Subject: Three Mile Island Nuclear Generating Station, Unit 1 (TMI-1)  
Operating License No. DPR-50  
Docket No. 50-289  
Thermo-Lag Response to Request for Additional Information

NRC letter dated November 20, 1996 (6710-96-3408) requested additional information regarding the TMI-1 request for exemption from 10 CFR 50 Appendix R, previously submitted by letters dated August 16, 1996 (6710-96-2229) and August 28, 1996 (6710-96-2301). The attachment provides an itemized response to each of the NRC questions.

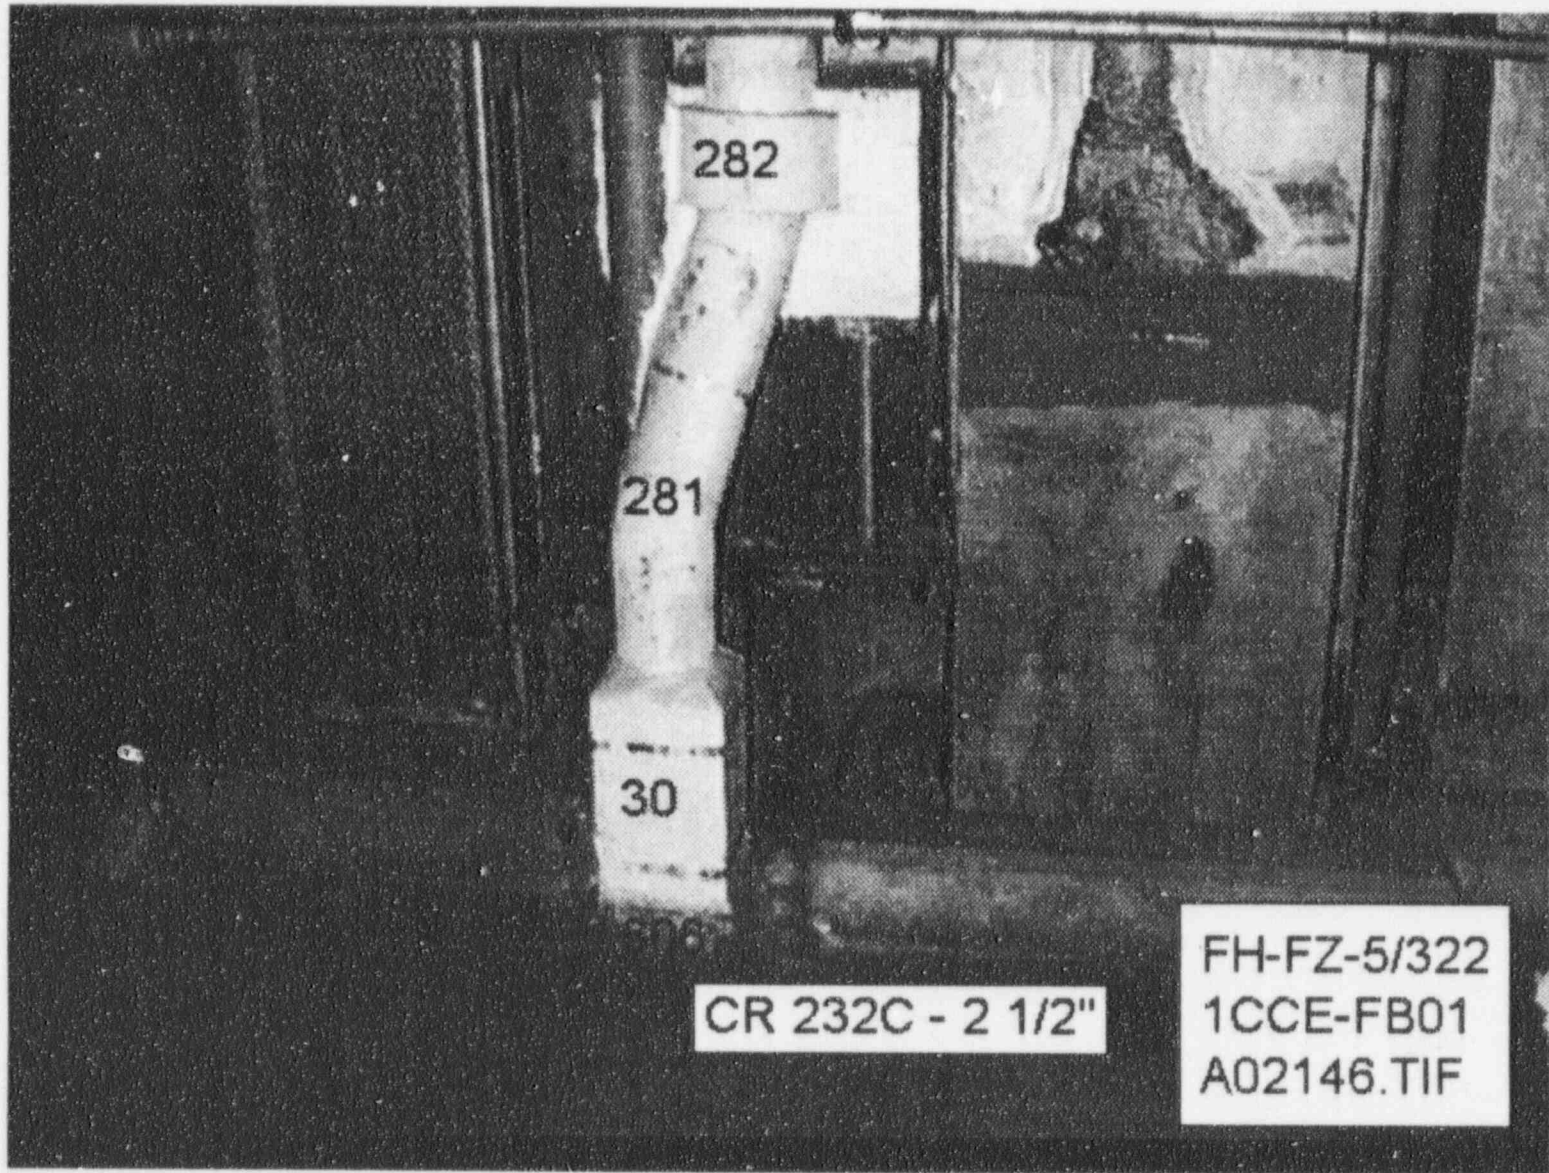
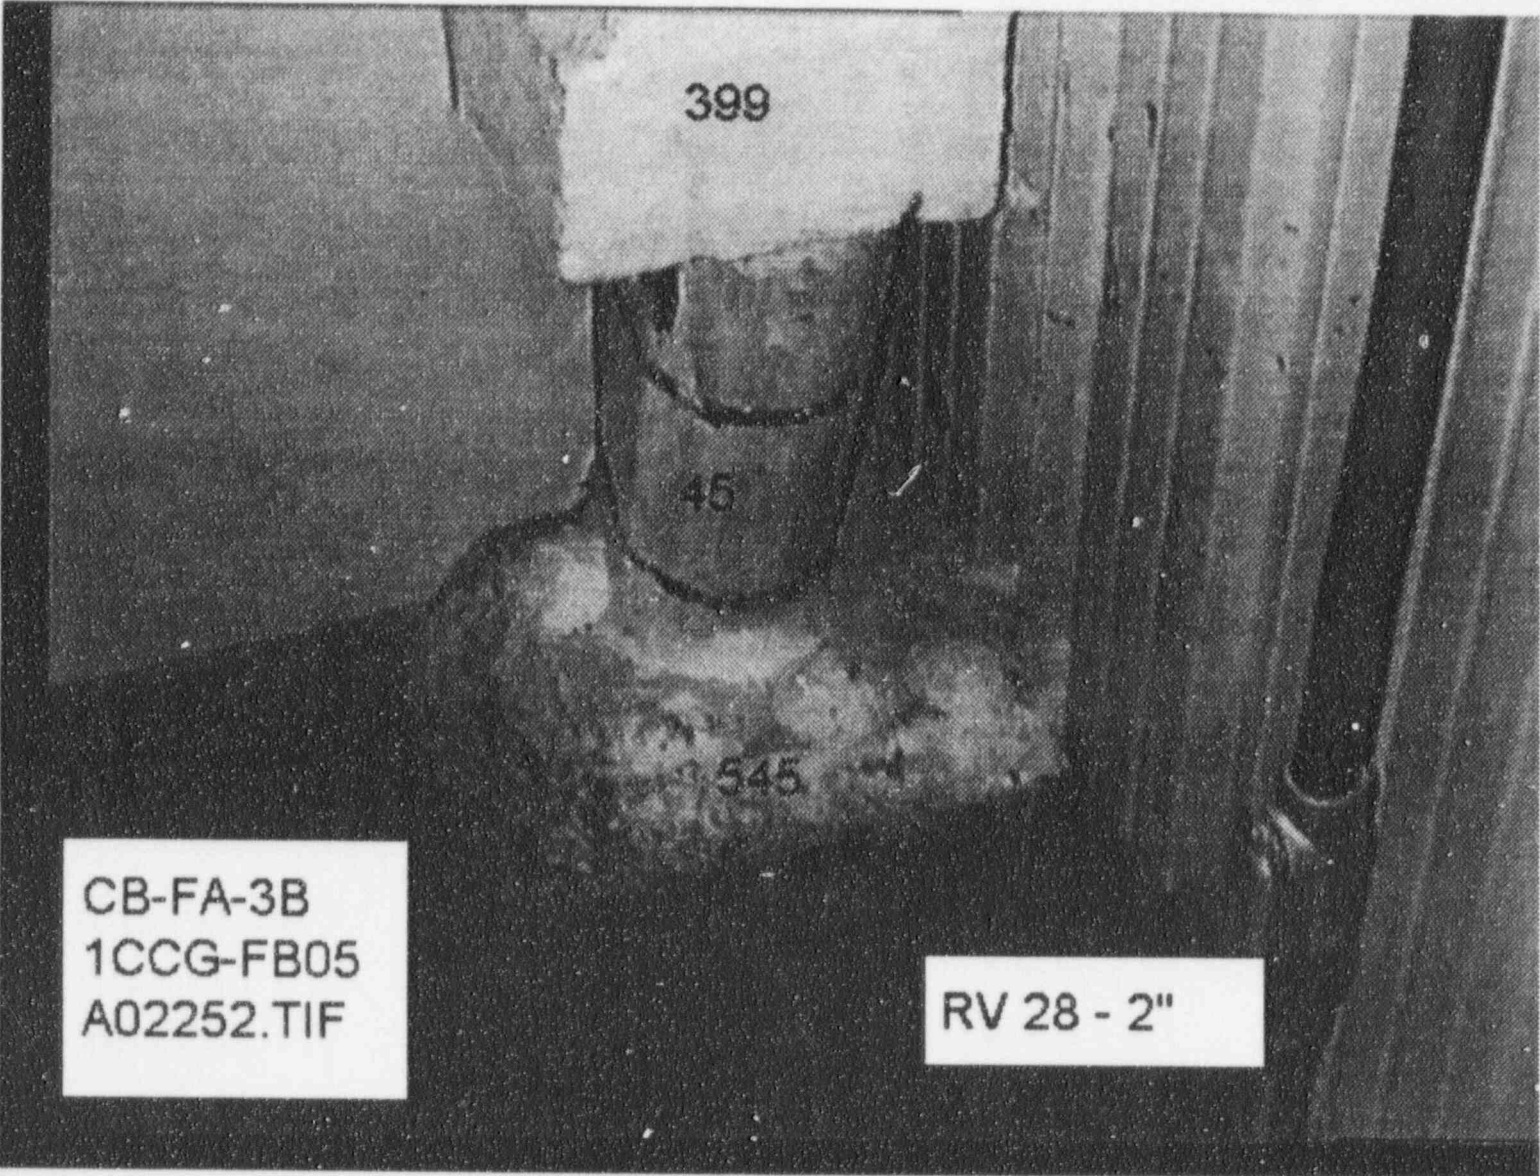
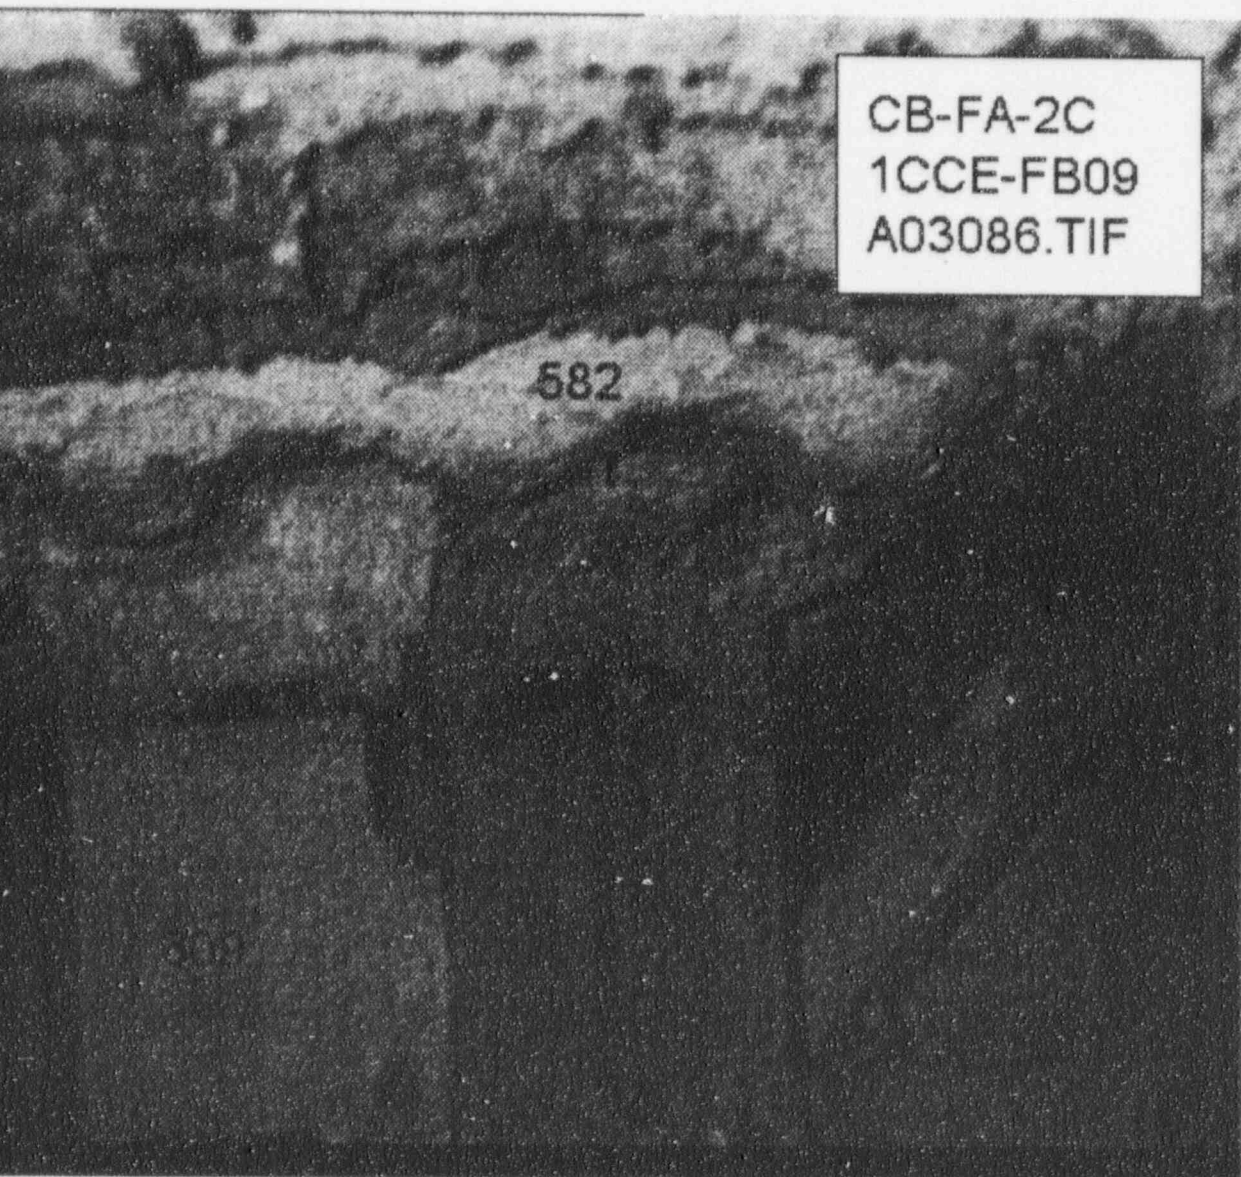
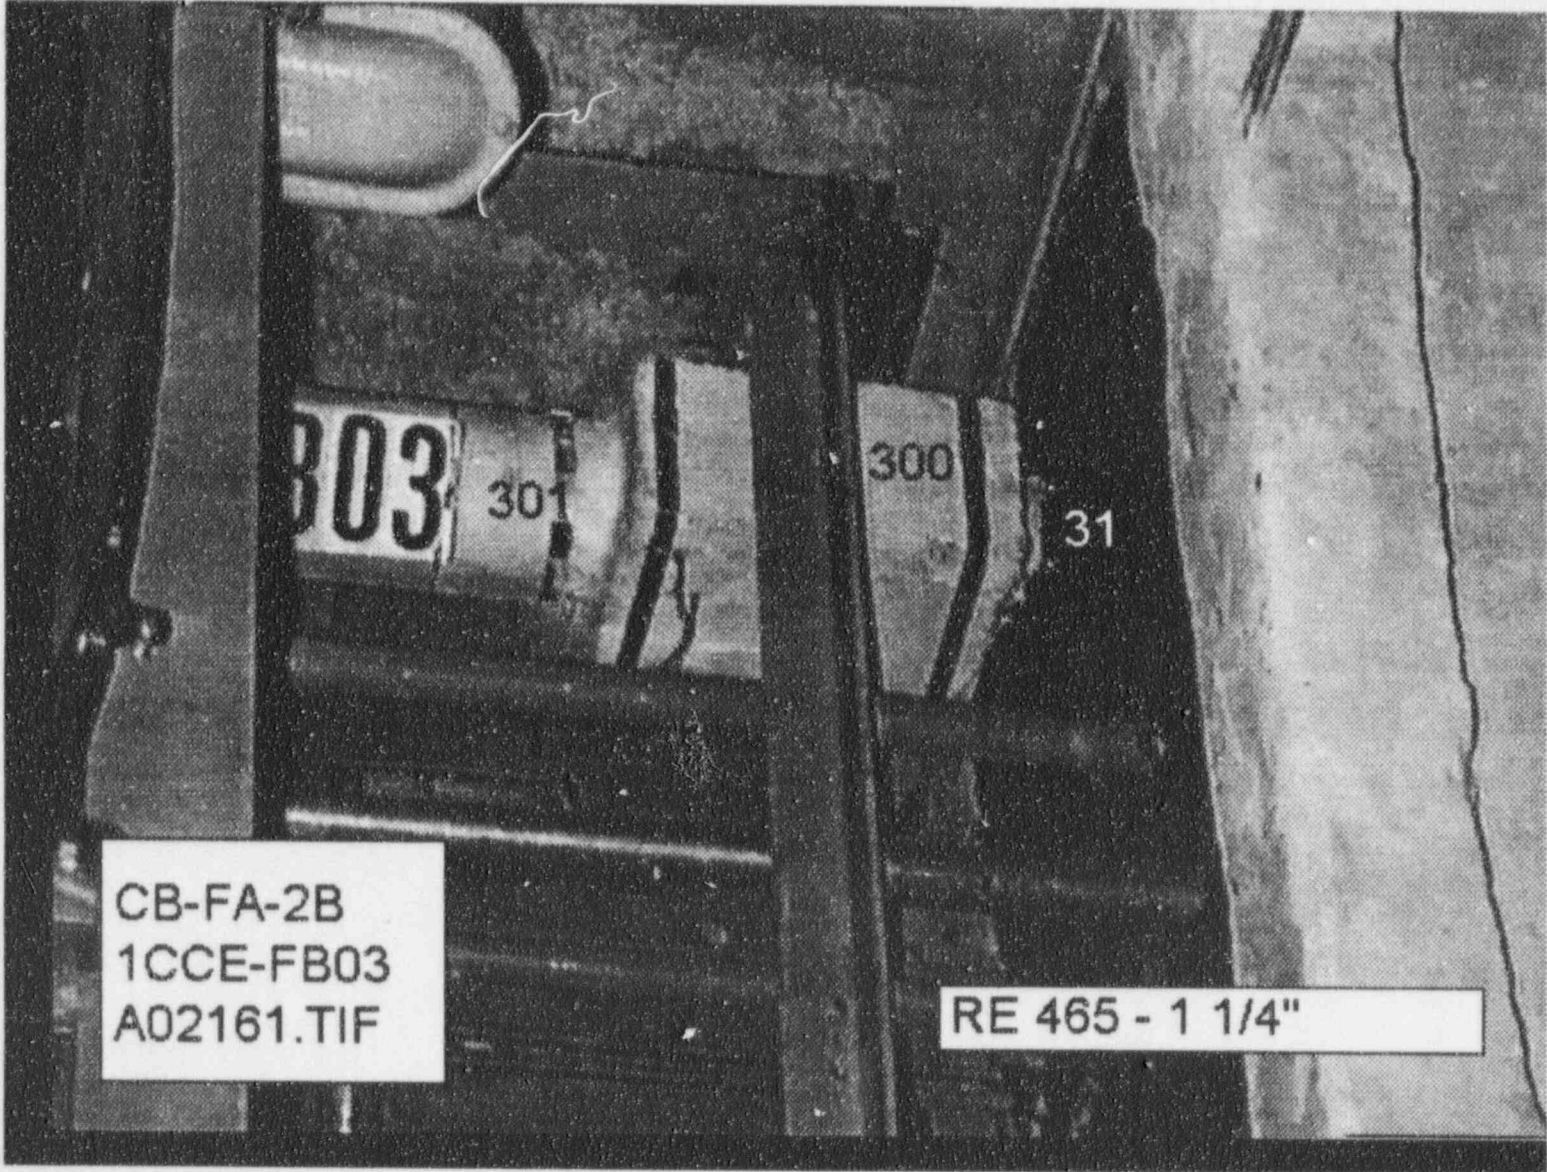
7. The following elements are listed as penetrations in Attachment 1 to Topical Report #094: 31, 573, 574, 582, 577, 578, 545, 605, and 606.

The NEI program did not test penetrations, and it is not clear from the evaluation of these elements how they are bounded by the fire tests that were discussed. Please clearly describe the configurations of these individual elements, as they are installed in the plant. Detailed drawings should be provided for further clarification. In addition, describe how these elements are bounded by the fire tests discussed in the evaluation.

The elements in question constitute elements which GPU Nuclear believes are adequately supported by NEI testing with respect to similarities in the construction of the interface point of Thermo-Lag fire barrier envelopes and the walls. Photographs of these elements are attached for information. Note that a photograph of Element 573 is not available; however, its configuration is as described below. We have modified how we designate these configurations in our electronic data base based upon our conference call of December 4, 1996. These configurations are now referred to as penetration interfaces in lieu of penetrations.

Element 31 is similar to the interface of all three conduits (6", 3", 3/4") in NEI Test 2-3 with the test deck. The NEI configuration extended the test item with 1"-thick preformed Thermo-Lag through the test deck and sealed around the outside of the barrier with silicone foam at the opening through the test deck. The only difference between the tested configuration and Element 31 is that in the test, ceramic insulation was installed on the underside of the test deck instead of bare concrete which is the case for Element 31. The construction of Element 31 is the same inside the penetration as inside the test deck, and silicone foam is commonly used as a penetration seal and has been tested successfully as a one-hour seal. This provides confidence that the GPU Nuclear configuration is a one-hour fire barrier. The NEI test, although not identical in configuration, provides additional level of confidence that this configuration is acceptable.

Elements 573, 574, 582, 577, 578, 545, 605 and 606 consist of interface joints at concrete walls where Thermo-Lag terminates at the wall and is joined to the wall by pre-buttering the end of preformed Thermo-Lag with trowel grade and attaching to the wall or installing a "picture frame" on the wall and abutting the end of a preformed panel to the picture frame as in Element 545. NEI Tests 3-1 and 3-2 used similar interface joints which were not the cause of the test failures. Therefore, it is concluded that a pre-buttered Thermo-Lag to concrete interface joint is not a potential weak link and has been shown to provide protection for at least 60 minutes for 1"-thick Thermo-Lag based upon the results of the aforementioned NEI tests.
